H. B. ROBINSON UNIT NO. 2

LICENSE DPR-23

TECHNICAL SPECIFICATIONS CHANGE REQUEST

SETPOINTS AND ΔP FOR STEAM FLOW

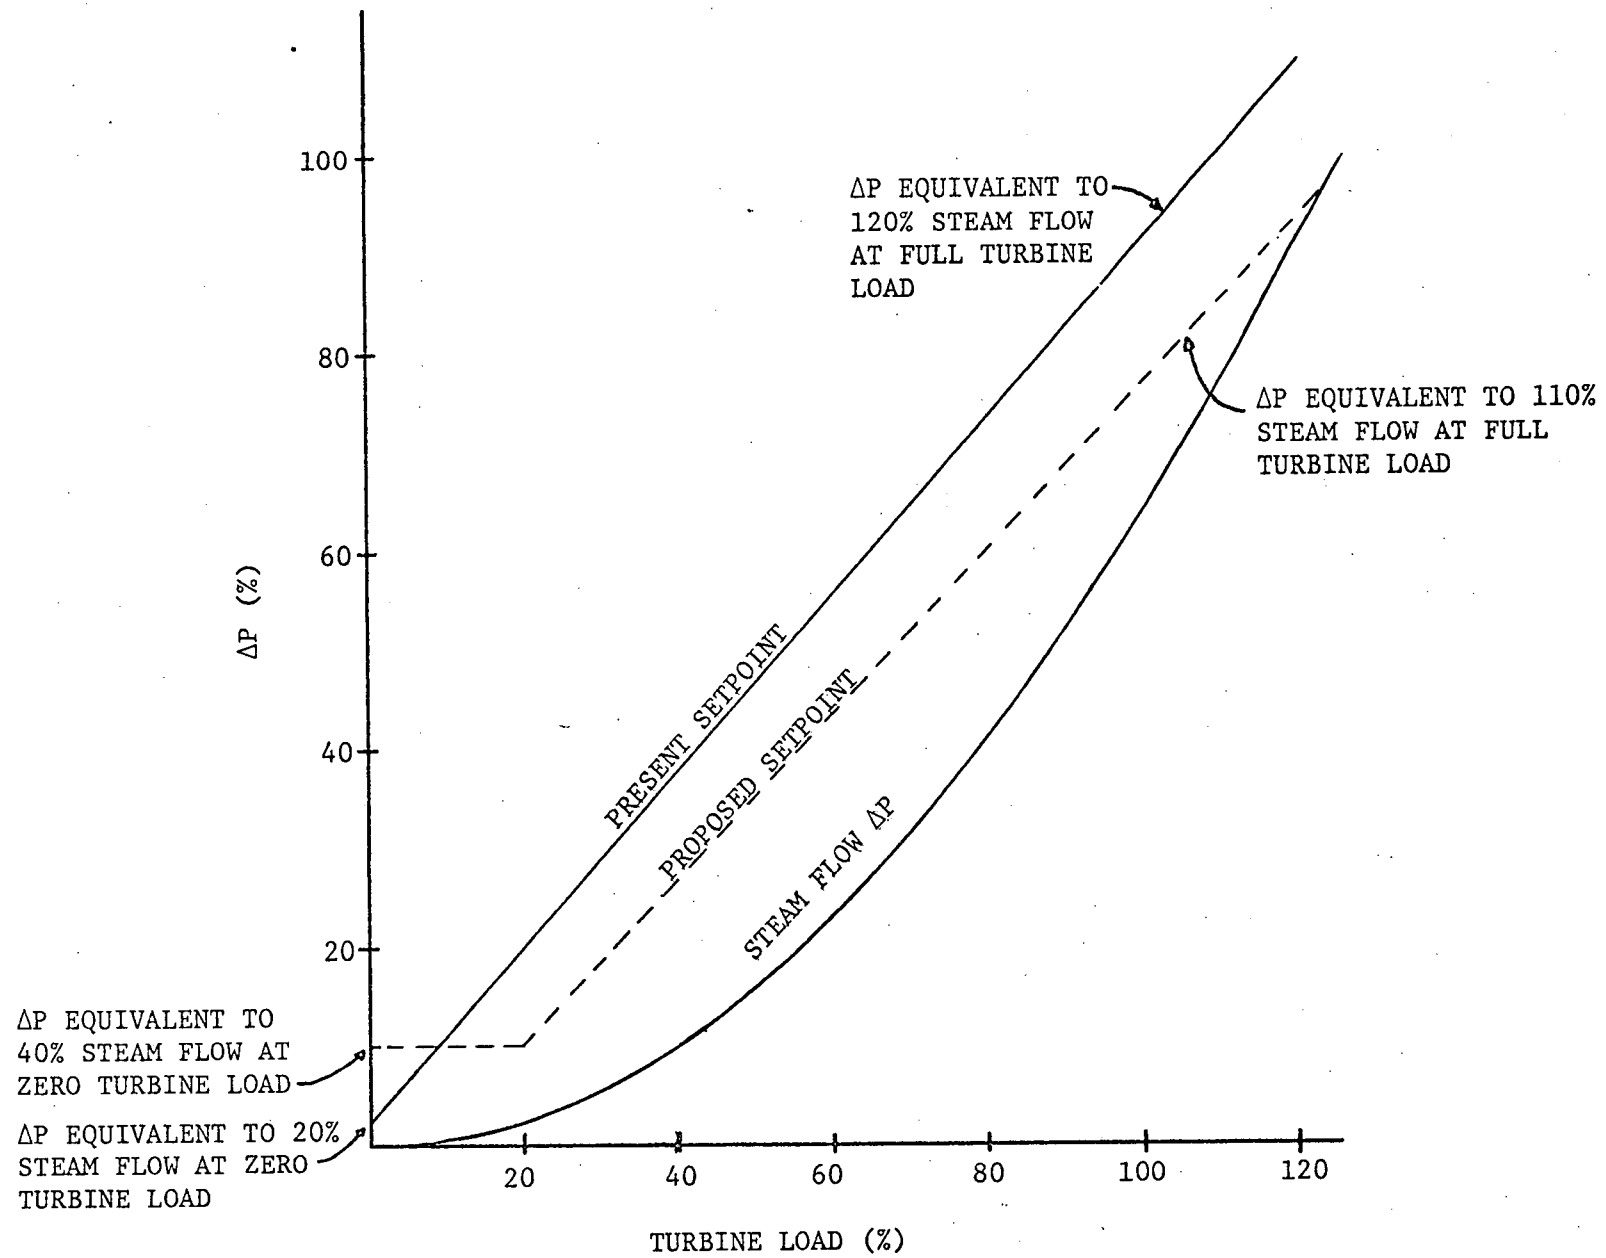
In the operation of the Robinson Plant, we have experienced spurious safety injections during plant shutdown and startup due to steam line flow differential pressure signal variations caused by instrument drift at very low power levels. A recent letter from the reactor vendor, Westinghouse, states that other Westinghouse PWR plants have had similar problems.

The current "Precautions, Limitations and Setpoints" document and the Technical Specifications set the limiting values at a differential pressure equivalent to 20% above the normal steam flow values at zero and full turbine load. A flow exceeding this condition coincident with either a "Low Tavg," or a "Low Steam Line Pressure" will actuate safety injection.

To eliminate the problem of spurious safety injection actuations during plant startups or unloadings, Westinghouse has developed a new "High Steam Flow" setpoint curve which can be accommodated by the present hardware (see figure). The setting for the differential pressure would be a constant from zero to 20% turbine load and a linear function from 20% to 100% turbine load. The zero and 20% load settings would represent a differential pressure equivalent to 40% steam flow at zero load steam pressure; the 100% load setting would represent a differential pressure equivalent to 110% steam flow at 100% load steam pressure. This new setting would be more conservative than the current values throughout the higher load range while through low and zero load conditions the new setpoints will be outside the range of normal differential pressure signal variation and will therefore eliminate spurious actuation of safety injection. This change does not affect the results of steam line break analyses of the Final Safety Analysis Report or the Fuel Densification Report for H. B. Robinson Unit No. 2.

- 3.5 Under Setting Limits, change the first sentence of Paragraph 5 on Page 3.5-4 to read as follows: "The high steam line flow limit is set at approximately 40% of the steam flow from no load to 20% load and at 110% of full steam flow at full load, with the steam flow differential pressure measurement linearly programmed between 20% load and 100% load in order to protect against large steam line break accidents."

<u>"No.</u>	<u>Functional Unit</u>	<u>Channel Action</u>	<u>Setting Limit</u>
5	High Steam Flow in 2/3 Steam Lines	a. Safety Injection* b. Steam Line Isolation	< Δ P Equivalent to 40% of full steam flow (at zero load), < Δ P equivalent to 40% of full steam flow (at 20% load), < Δ P equivalent to 110% of full steam flow (at full load), Δ P Linear from 20% to 100% load.
	Coincident with Low Tavg or Low Steam Line Pressure		>541 ^o F Tavg >600 ^o psig steam line pressure"
